Serial No. 10-713  
NSSL/WEB R0  
Docket No. 50-423  
License No. NPF-49

**DOMINION NUCLEAR CONNECTICUT, INC.**  
**MILLSTONE POWER STATION UNIT 3**  
**REMAINING RESPONSE TO REQUEST FOR ADDITIONAL INFORMATION**  
**REGARDING GENERIC LETTER (GL) 2004-02**

**MILLSTONE POWER STATION UNIT 3**  
**REMAINING RESPONSE TO REQUEST FOR ADDITIONAL INFORMATION**  
**REGARDING GENERIC LETTER 2004-02**

Figure 1: Ottawa River Water Level High and Peak MPS3 Rig 33 Test Head Loss

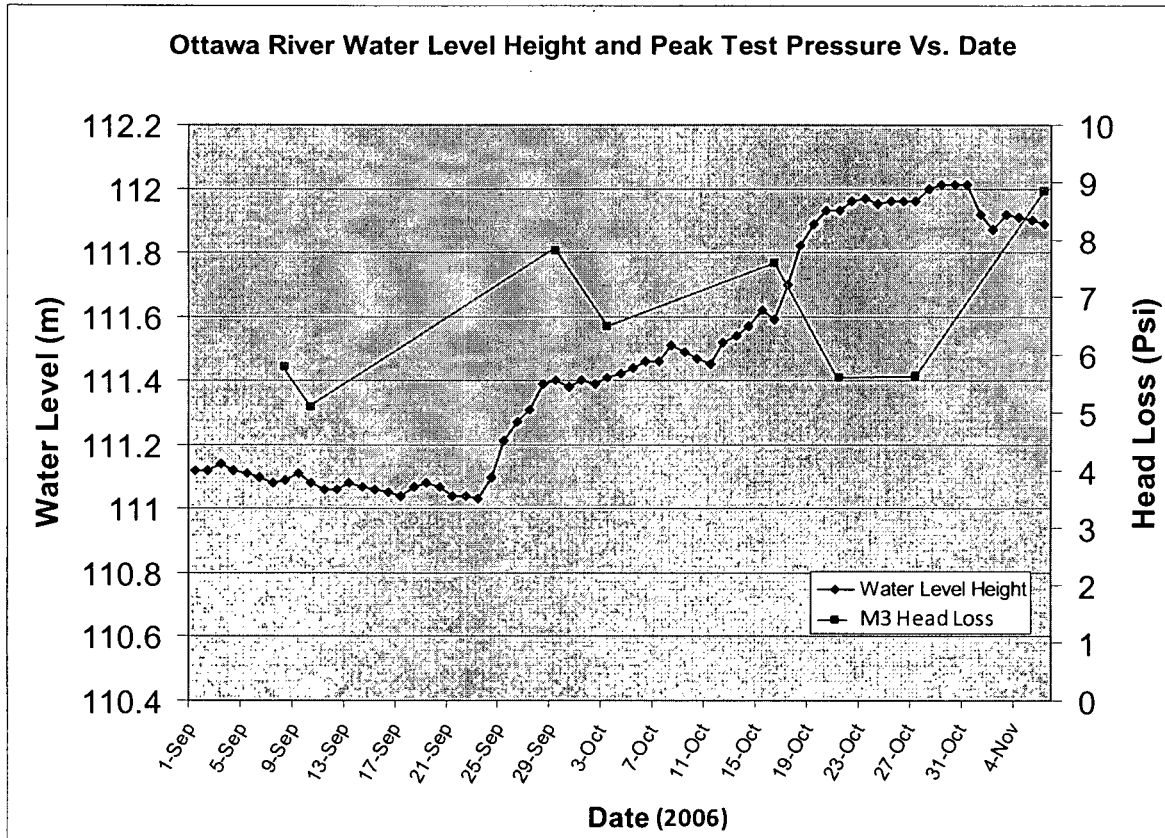
- a. Provide an evaluation of the degree to which the particulate and biological growth from the river water affected the results of MPS3. It appears that the MPS3 tests were affected to a much greater degree than other AECL tests conducted under similar conditions. Please discuss the reason MPS3 was affected to a greater degree.*

The water level height of the Ottawa River could also affect the concentration of river particles and slime forming organisms. Higher water level resulted in higher peak head loss as shown in Figure 1.

Figure 2: Theoretical Air Evolution at a Point on the Strainer Submerged by 26 Inches

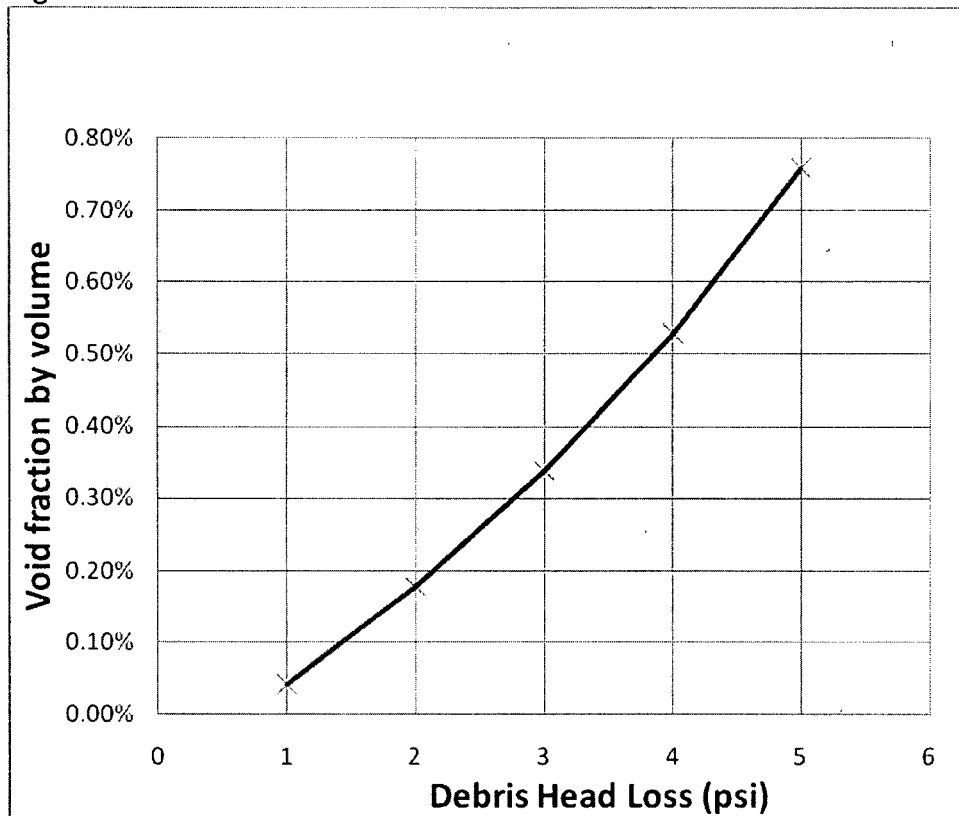
- a. Please provide an evaluation of how the air evolution phenomenon affected the MPS3 tests compared to other AECL tests conducted under similar conditions. Please provide information on why air evolution, as a factor in head losses, would only occur for AECL strainers.*

Based on a dissolved air calculation, it was found that air evolution increases significantly as the head loss across the debris bed increases. Figure 2 shows a theoretical plot of how air evolution is affected by debris head. This plot assumes that air will immediately evolve out of solution if it exceeds the saturation concentration. However, it is likely that there is some time delay and the actual air release would be less than indicated. Nevertheless, for a relatively small head loss, air evolution is very low and it starts to become more significant as head loss exceeds approximately 2 psi. The tests performed for other Dominion plants had head losses less than 2 psi, which was not enough to cause significant air evolution.

Figure 4: Air Bubbles Emerging from Discharge Header in MPS3 Large-Scale Test

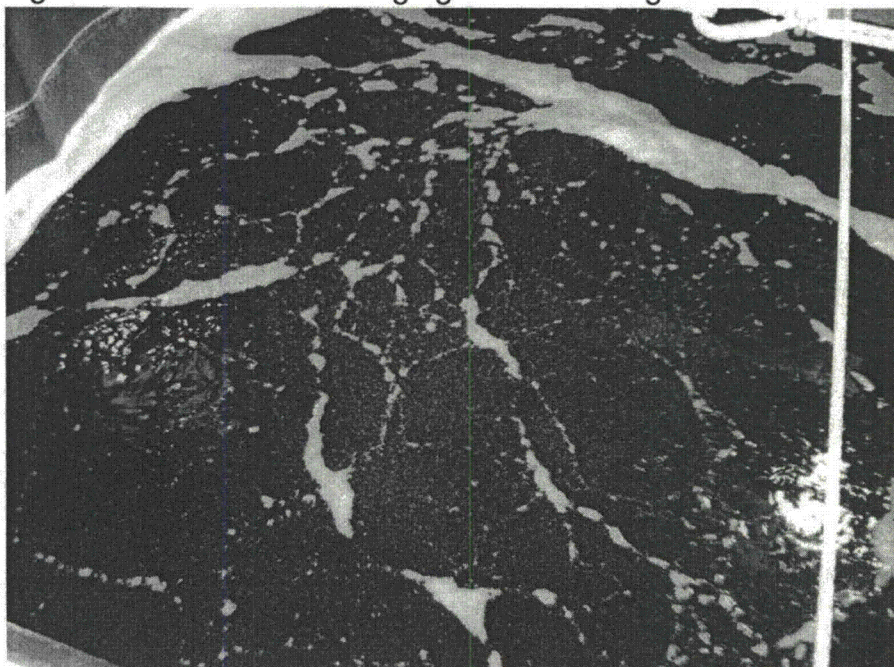
- b. The response to RAI 4 stated that the air evolution began to affect head loss as soon as the fibrous debris was added to the test and that the head loss began to decrease as soon as fibrous debris additions were stopped. Please provide an evaluation of why the air evolution would begin to affect head loss as fiber was added to the test and why it would stop as soon as fibrous debris additions were stopped.*

The MPS3 large-scale test M3L-2 was performed in the AECL large-scale strainer testing facility—Rig 85. In that test, many air bubbles were observed emerging from the discharge header after the third fiber addition, as shown in Figure 4. The discharge header was located on the floor of the test tank. During the test, the head loss stabilized at 2.7 psi after the second fiber addition. The third fiber addition increased the head loss to 4.1 psi. Three more fiber additions were added into the test and each addition caused a spike in head loss as shown in Figure 5. DNC's response to RAI 4, dated March 13, 2009, referred to the fourth, fifth and sixth fiber additions. Prior to these fiber additions, air evolution had already reached a significant level due to high debris bed head loss.

Figure 7: Debris Bed at the End of MPS3 Chemical Effects Test

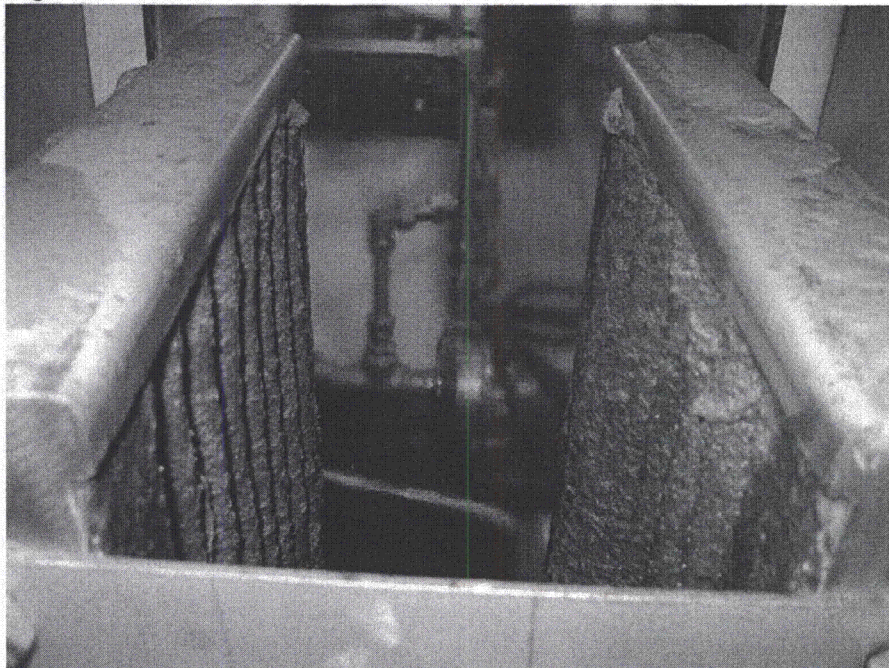
*Please provide an evaluation of the potential for the lower head loss in the Rig-89 testing (versus reduced scale testing) to have been caused by agglomeration of debris, especially fibrous debris.*

The potential for the lower head loss in the Rig 89 testing to have been caused by agglomeration of fibrous debris was very low. Fibrous debris was sprayed as “single fine” by using a high pressure jet flow in a 200 liter plastic barrel. The sprayed fiber was then added into the in-line debris addition tank. The debris addition tank was equipped with a stirrer. After a batch of fibrous debris was added into the tank, the stirrer was activated to suspend the fiber and to avoid debris settling or agglomeration. The debris addition tank was then valved-in to let the fiber flow to the strainer box slowly by adjustment of the in-line control valves. (Figure 7)
